Re: 09-AFC-6 Blythe Solar Power Plant Project

Docket No. 09-AFC-6

**TESTIMONY OF MATTHEW F. HAGEMANN**  
**ON BEHALF OF CALIFORNIA UNIONS FOR RELIABLE ENERGY**  
**FOR THE BLYTHE SOLAR POWER PROJECT**

**Figure 1: Project Location Map, FUDS and Ranges**

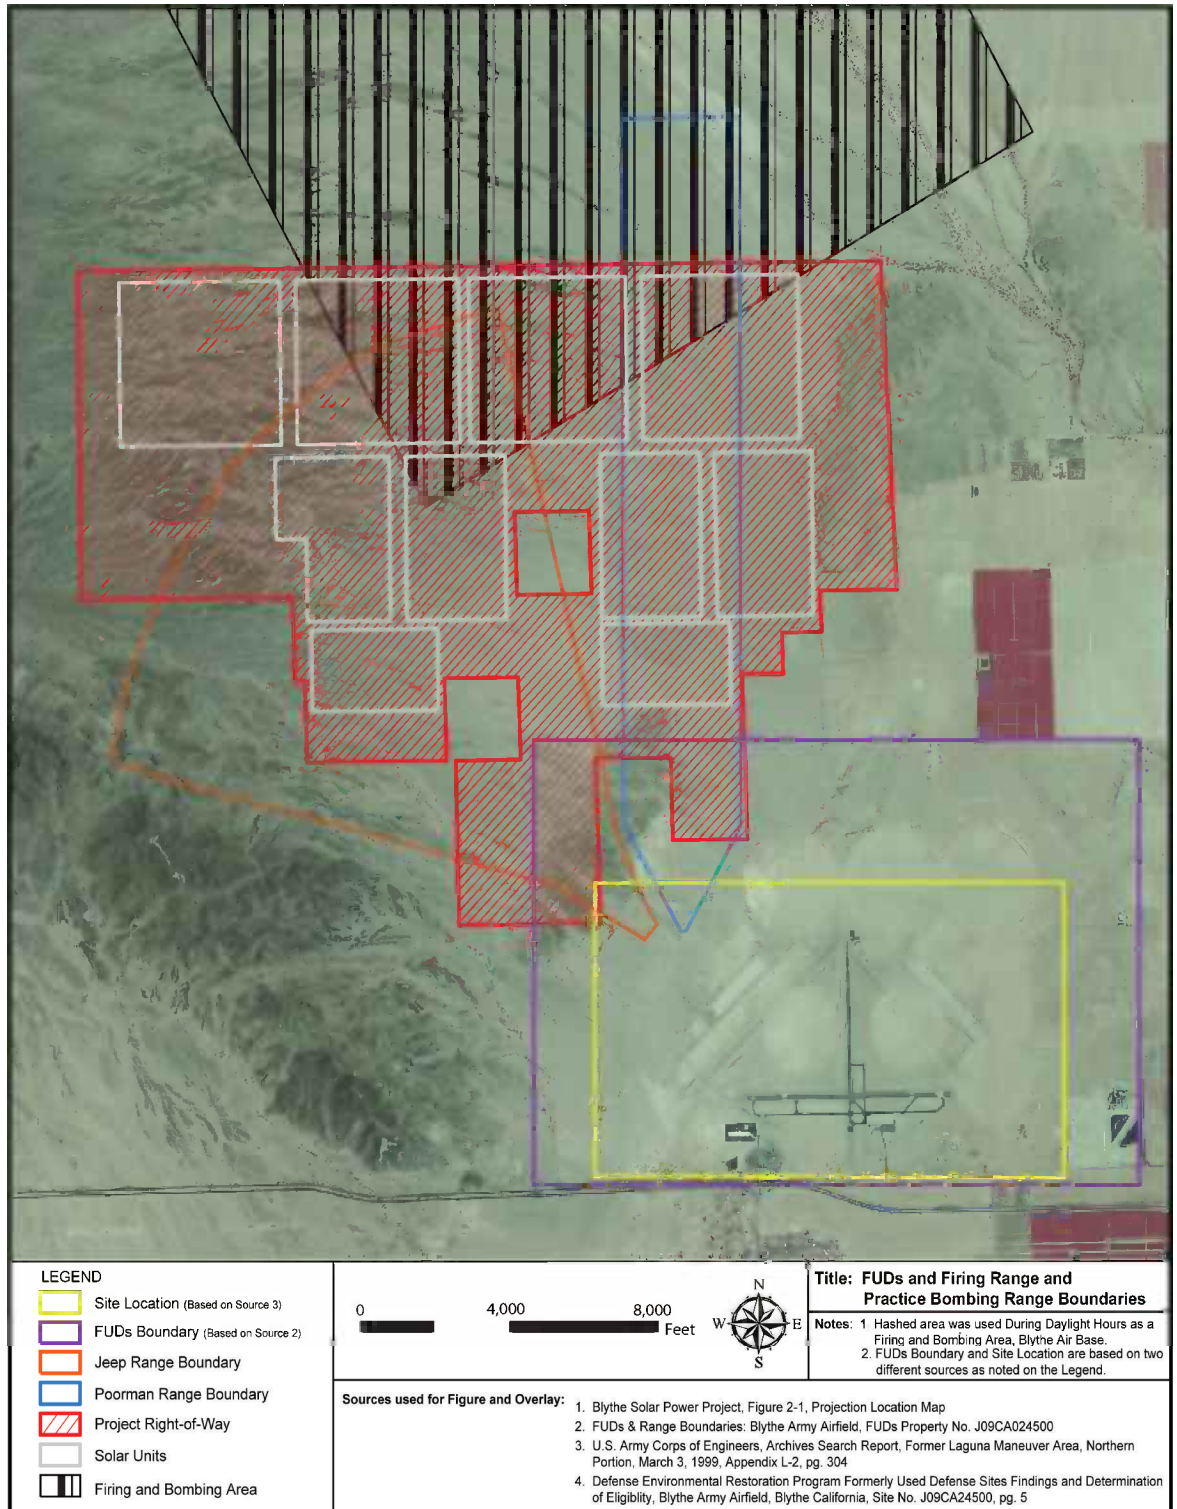
<sup>13</sup> Please note that the Corps misidentified the locations of the fans: the location of the Poorman Range and the Jeep Range were switched in the map the Corps prepared (Attachment 4) when compared to the map prepared by the Army (Figure 2 and Attachment 3). We confirmed the transposition of the ranges by identifying the location of the Jeep Range in current aerial photographs in a location consistent with the Army map in Figure 2 and Attachment 3. For purposes of the mapping in Figure 1, we corrected the locations.

Poorman ranges were used at bases across the U.S. for training in aerial gunnery. The ranges were developed to simulate conditions encountered by aerial gunners. The gunner learned turret operations and safety procedures while firing at silhouettes of a fighter that moved toward trainees on a track. The turrets generally had twin-mounted .50 caliber machine guns. The range fan associated with the Poorman Range at the Blythe Army Airfield is shown below in Figure 1 to extend more than 4 miles into the Project right of way.

The range fan associated with the Jeep Range at the Blythe AAF is shown below in Figure 1 to extend 3 miles into the Project right of way.

The Applicant identified the Poorman and the Jeep ranges to be within the Project boundary in responses to Staff's data requests.<sup>27</sup> However, the Applicant and Staff failed to identify and analyze the range fans, or safety areas for the Poorman and the Jeep Ranges that would extend almost across the entire Project area.<sup>28</sup>

**Figure 2: Excerpt from 1943 Boundary Sketch**

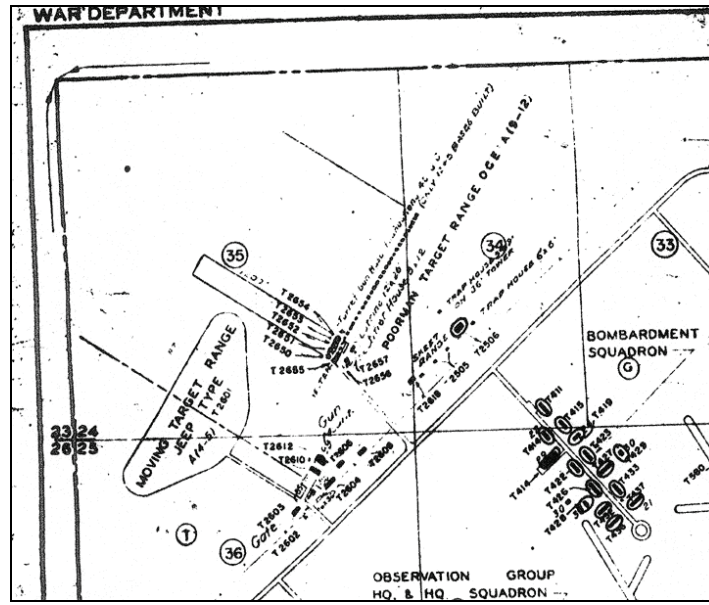
A Poorman gunnery range, skeet range, and jeep type target range, all with ammunition storage, were constructed and used by Army personnel.<sup>9</sup> The locations of the ranges are excerpted in Figure 2 below as obtained from the National Archives.<sup>10</sup>

Safety fans<sup>11</sup> associated with these ranges extend into the Project site, as shown in the figure below and in Attachment 4.<sup>12,13</sup>
